Axiom Hand tap leak – Recall Product Identification

Axiom Hand Tap leak - Retrofit instruction

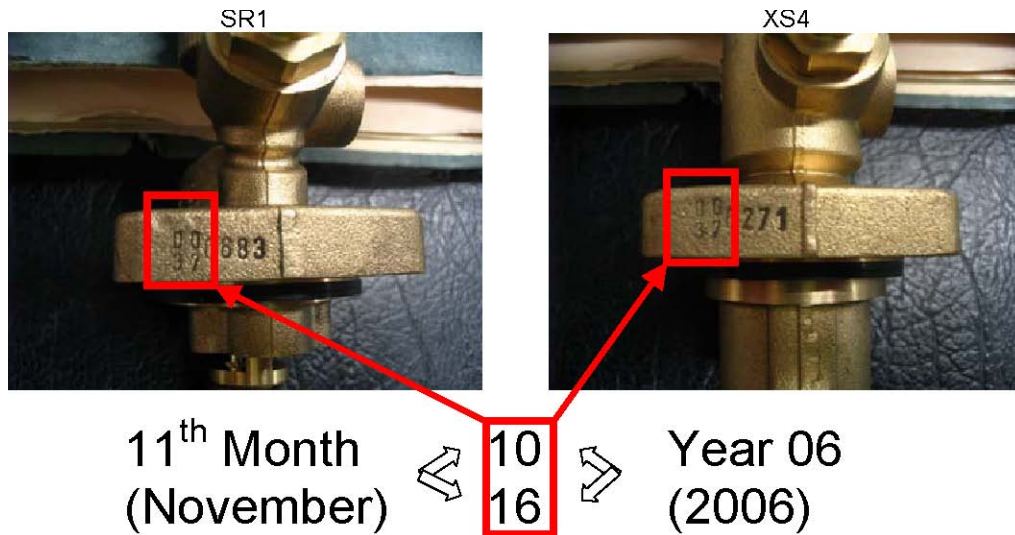
The Axiom hand tap is easily identifiable from the label shown in the photo below.

Hand taps requiring retrofit were potentially fitted to “APA” tanks with a manufacture date **from 01/11/2006 to 30/03/2007.**

If the tank falls **OUTSIDE** this date range then the hand tap **DOES NOT** require retrofit. Therefore tanks installed prior to 01/11/2006 do not require the hand tap to be retrofitted.

If the tank falls **WITHIN** this date range then the manufacture date of the service valve must be checked. **Any service valve with a manufacture date from and including November 2006 to and including February 2007** will require the hand tap to be replaced.

If the hand tap requires replacement and you have not already received hand tap exchange kits, please send an email to handtap07@apamfg.com.au or call (03) 9761 5840 to arrange supply of the hand tap exchange. Follow the [Axiom Hand Tap leak - Retrofit instruction](#) to replace the hand tap. Only use hand taps from the exchange kits. These can be identified by a green dot on the top of the spindle.
